Our Reference: 0178462_RESPONSE TO FURTHER INFORMATION REQUEST_APRIL2016.DOCX

RE: BIALA WIND FARM - REQUEST FOR FURTHER INFORMATION

I refer to the Department of Planning & Environment (DPE) request to Newtricity, as the Proponent of the Biala Wind Farm Project (SSD 13_6039), seeking further information relating to the environmental assessment of the Project as outlined in your email of 29 March 2016 and discussed at our meeting of 8 April 2016, and subsequent email requests of 31 May, and 2 and 10 June 2016 (copies attached in *Annex A*). Outlined below is our response to your queries and additional information as requested.

Viewpoint 11 - Photo 11A - Simulated view northwest towards proposed Biala Wind Farm from location of proposed property DA18

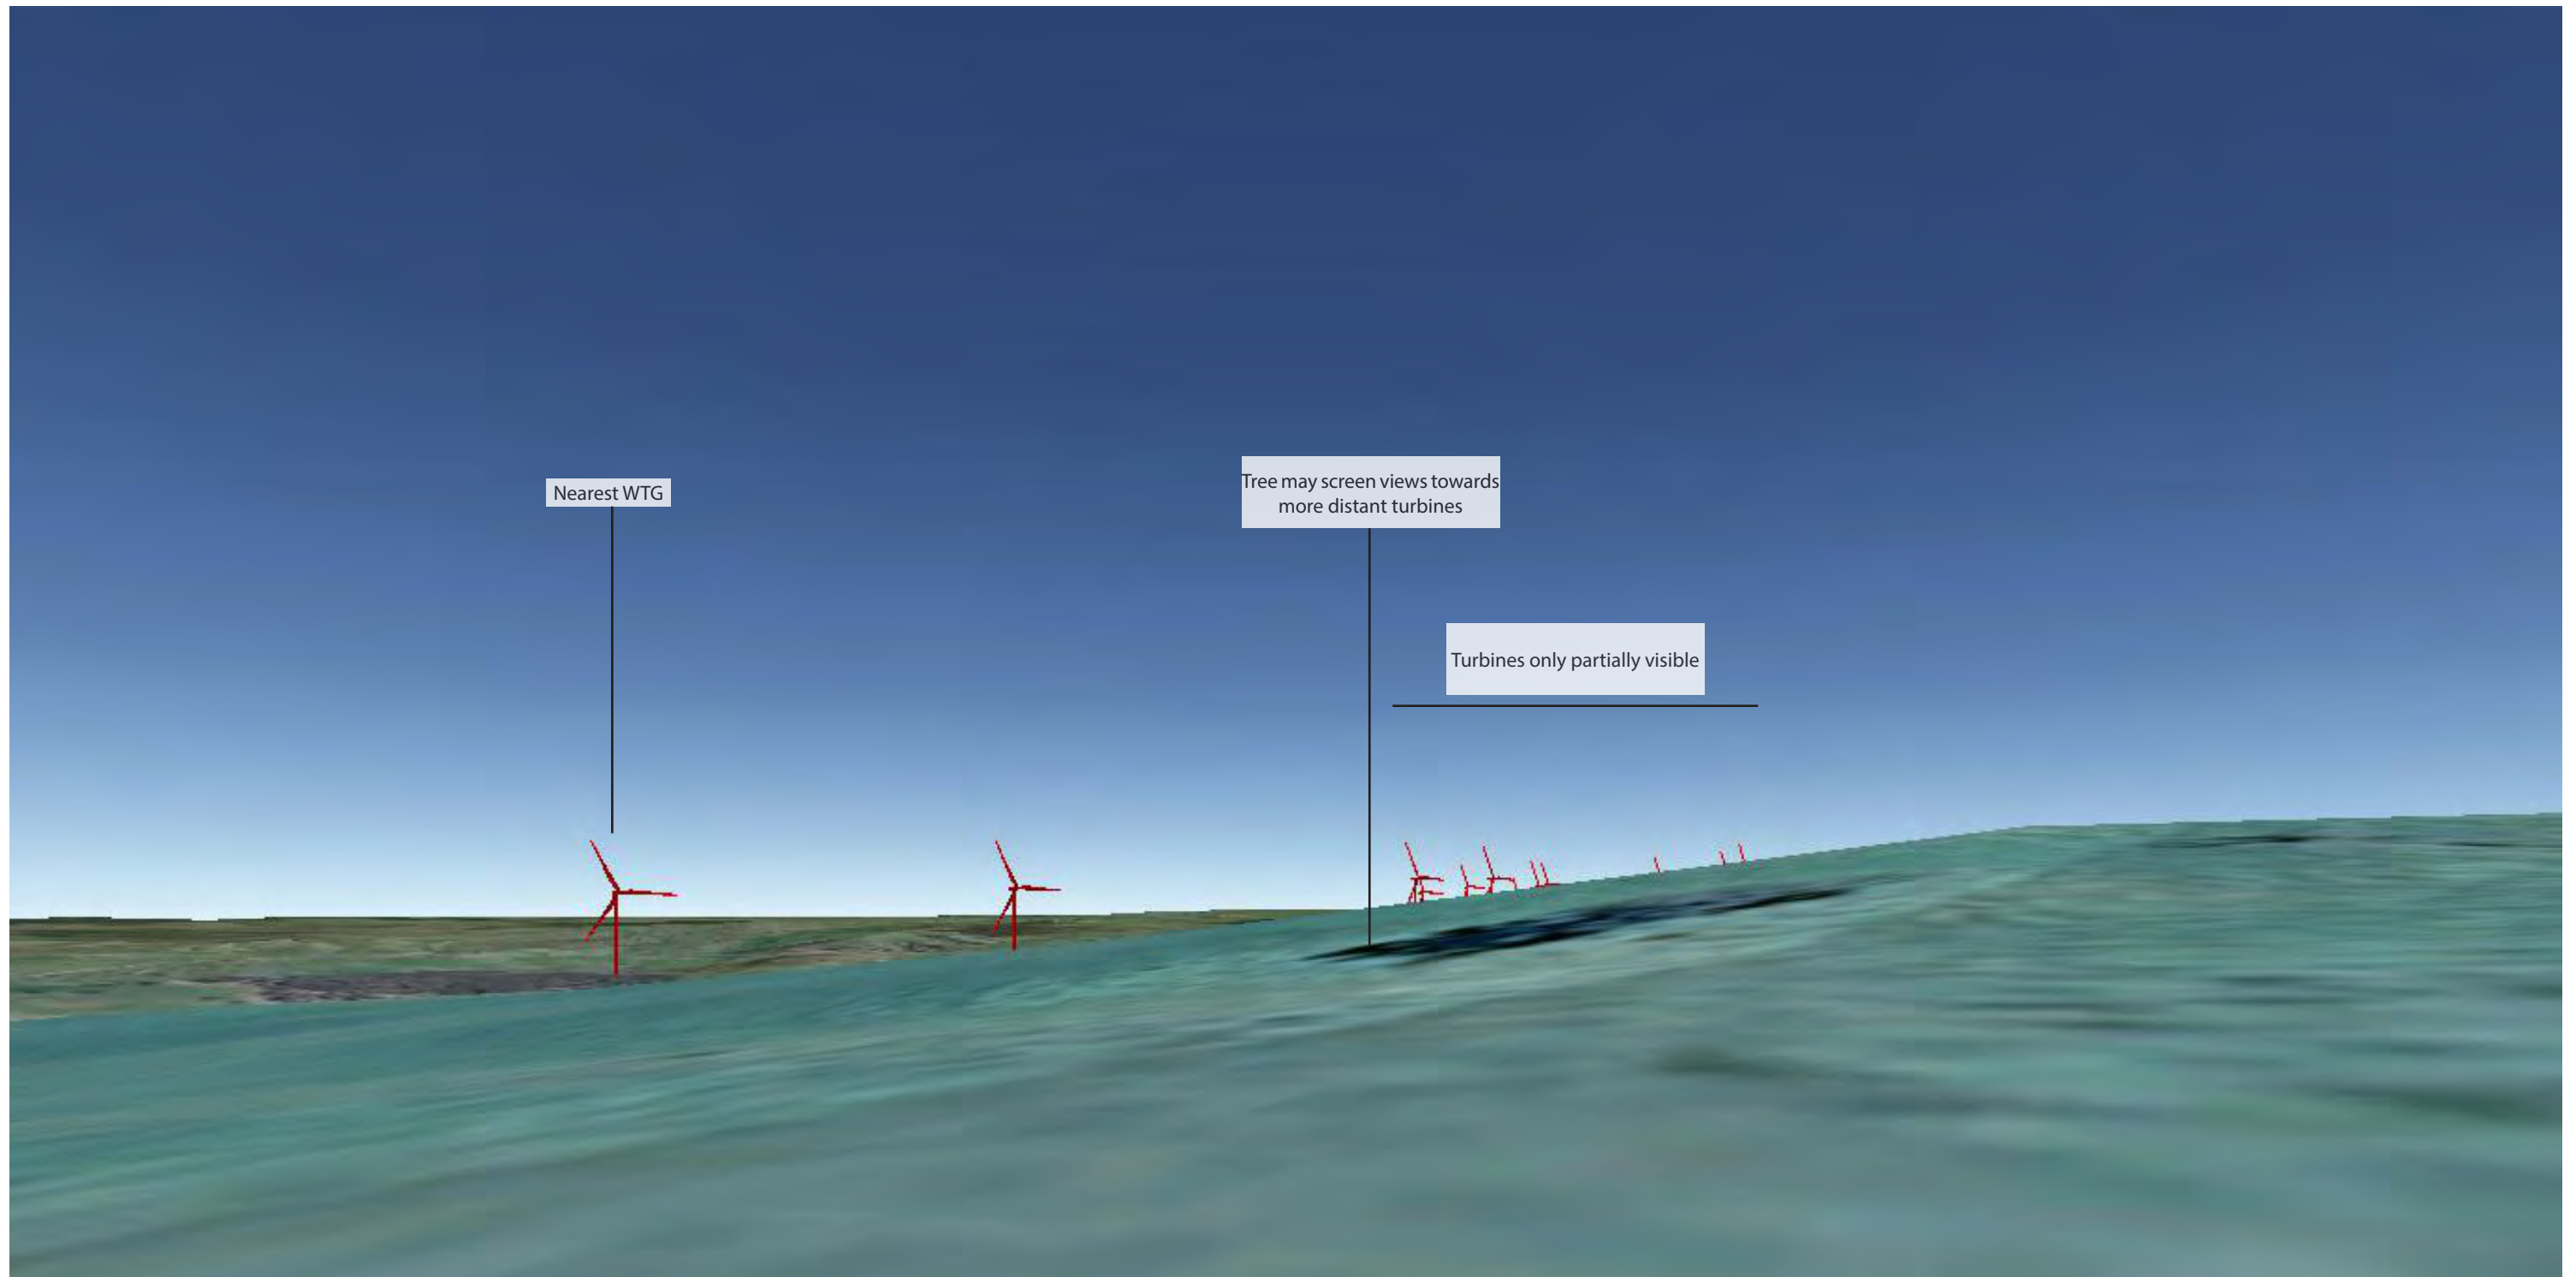
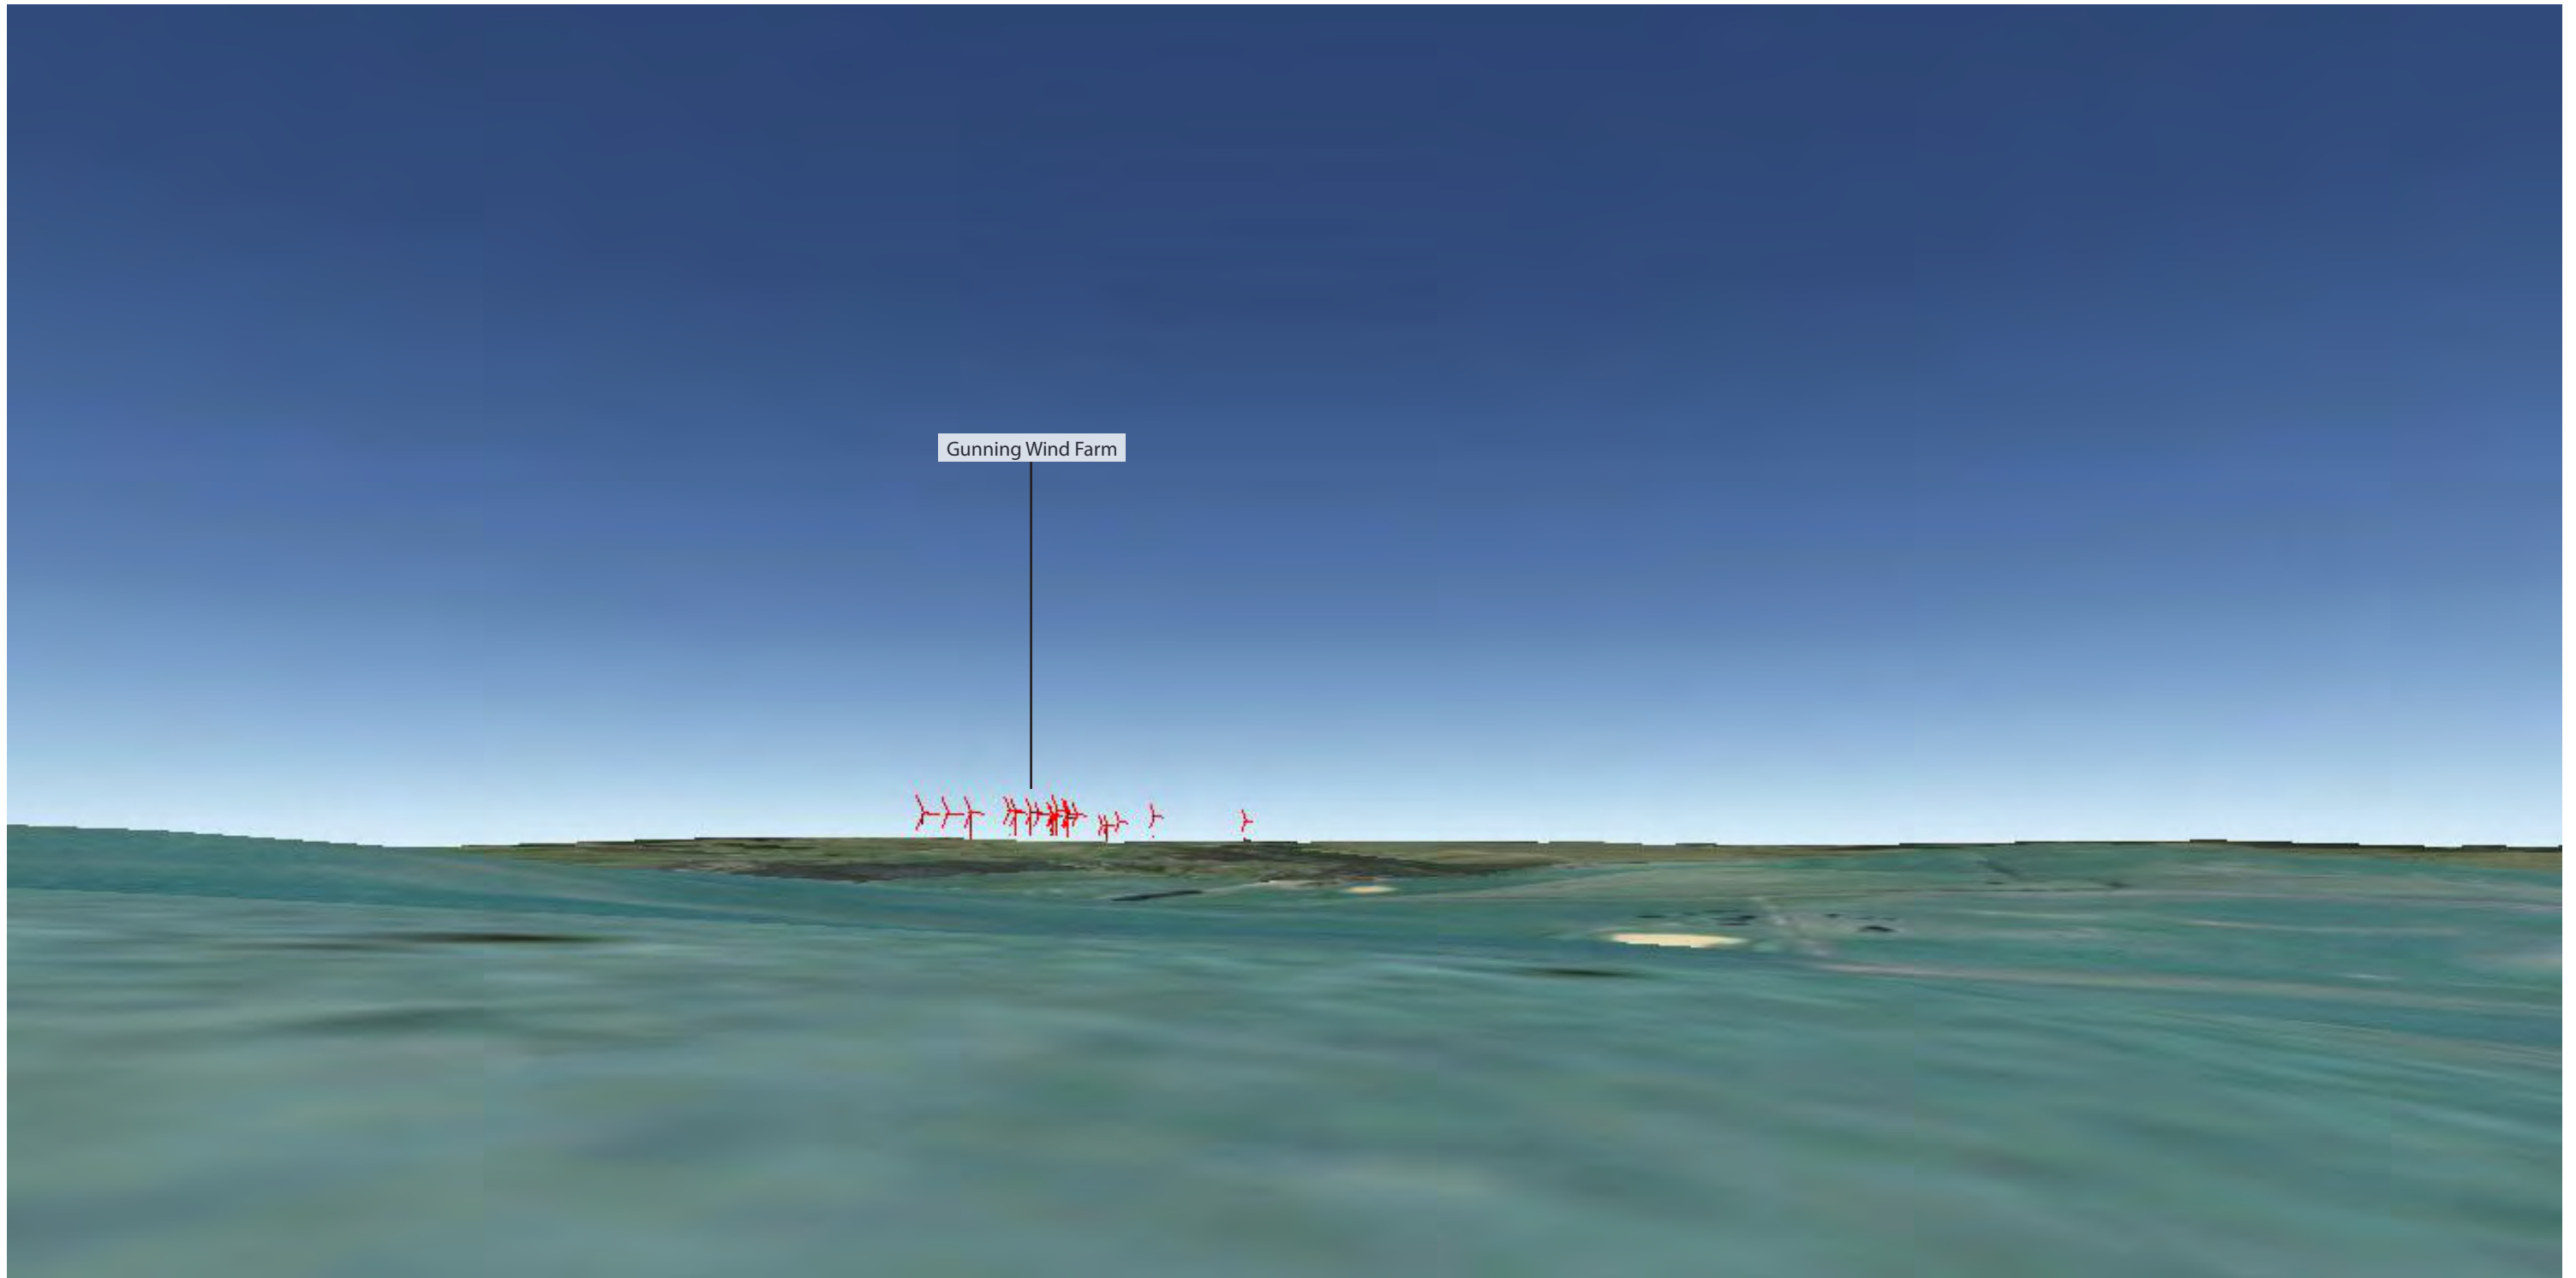
In addition, Clouston Associates further updated the analysis in June 2016 in response to additional information provided by DPE regarding the confirmed location and proposed orientation of the dwelling referred to as 'DA18' located off Gurrundah Road, southeast of the PA. The precise location of this proposed dwelling was previously unknown as it had not been specified on the Council approved DA plans nor confirmed by the landowner. In the absence of this information, the Rts Report incorporated assessment of potential impacts at this dwelling that included assumptions regarding the potential 'worst-case' siting of this dwelling within the lot with respect to predicted visual impacts. The confirmed location of the dwelling does not reflect this 'worst-case' scenario, and hence the visual analysis has been updated to reflect the confirmed location and amended impact ratings.

Current view	Expected Visual Impact
The approved DA property site sits on a elevated hill, southeast of the topographical peak. There are likely to be expansive and far reaching views available to the west, south and east. A patchwork of fields, stands of woodland and individual tree plantings would be visible, stretching to the horizon. WTGs associated with Gunning Wind Farm would be visible to the south at a distance of approximately 6.7km. Views to the north will be mostly blocked by the elevated topography of the hill.	A simulated view of the Project from this property has been created using Google Earth and 3D modelling software - as shown in Photo 11A and B. As shown in 11A, the two closest WTGs would be clearly visible to the northwest at a distance of approximately 2.1km. Blade motion would be discernible. The upper portions of 10 more distant turbines to the north may also be visible, partially obscured by the elevated ridge line of the hill. The majority of these WTGs would only be visible as blade tips and these WTGs may be obscured by a tree within the foreground. Overall, a moderate impact rating on visual amenity is expected from this location. The presence of existing WTGs within the viewfram, along with the southerly orientation of the dwelling reduce the sensitivity of the receptor to visual change. The visible Biala WTGs will appear within a panoramic viewframe and a significant impact on visual amenity is not expected.

Overall Visual Impact Rating	MODERATE
------------------------------	----------

Figure 6: Map of the proposed Biala Wind Farm with turbines, dwelling locations and theoretical annual shadow flicker duration at 2 m above ground level

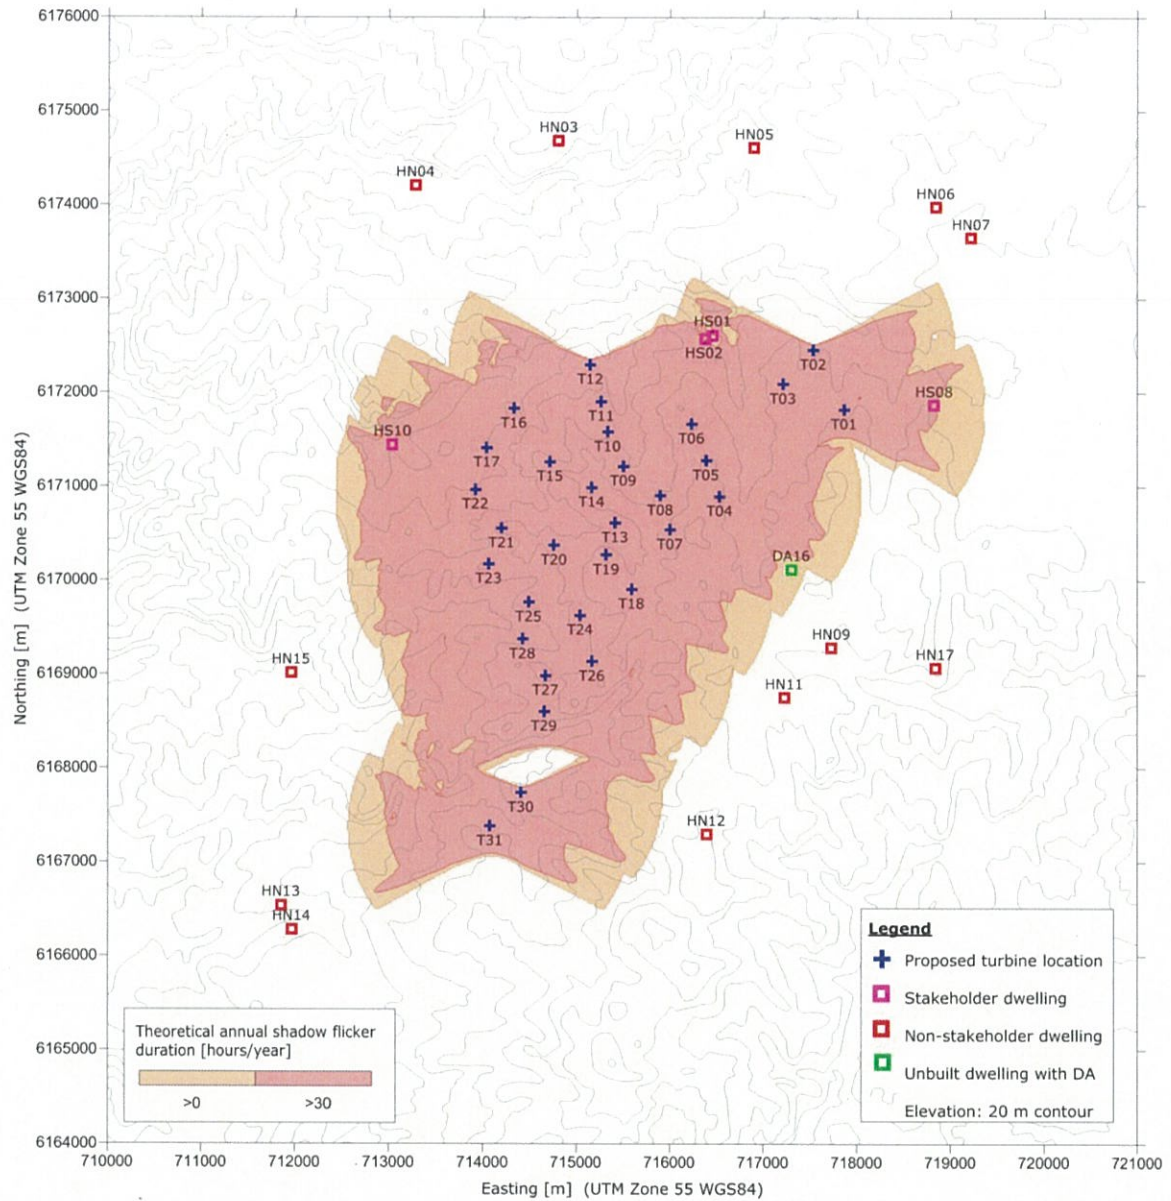
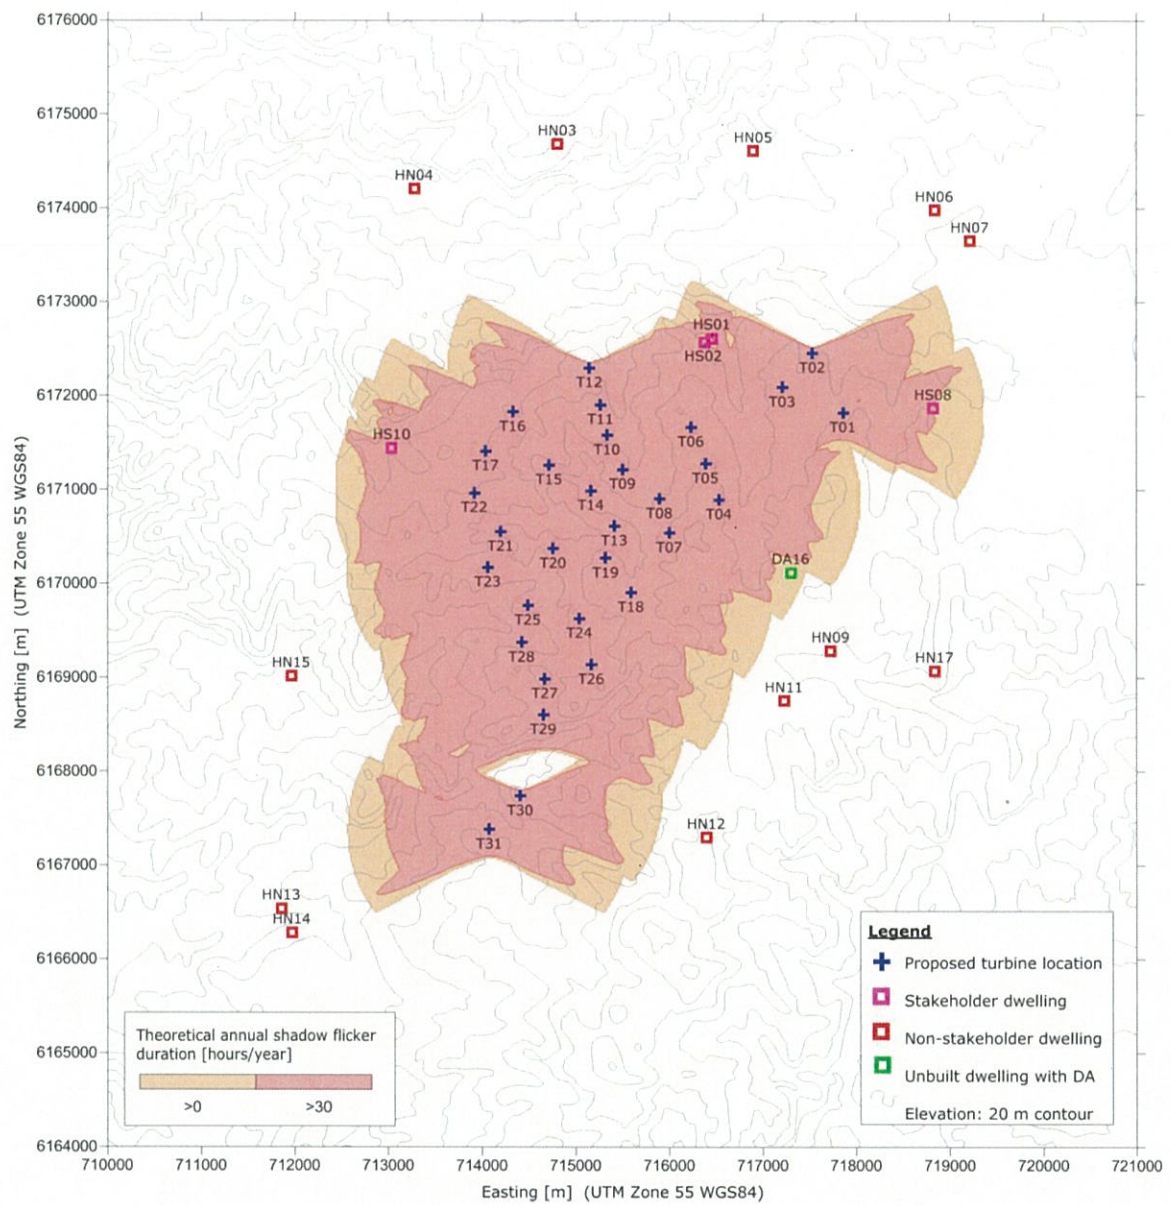
At the meeting of 8 April, DPE noted that the EIS and RtS Reports did not clearly demonstrate that two dwellings located along Church Lane / Bertalba Road had been considered and assessed for potential environmental impacts associated with the Project. DPE requested confirmation that these dwellings have been adequately assessed, specifically associated with potential visual, noise and shadow flicker impacts.

As illustrated in Figures 6 and 7 of the Shadow Flicker and Blade Glint Assessment (figures reproduced in *Annex C*), H03, along with H03a and H03b, are all located well outside the predicted impact envelope for theoretical annual shadow flicker durations, and therefore there should be no shadow flicker impacts at any of these dwellings.
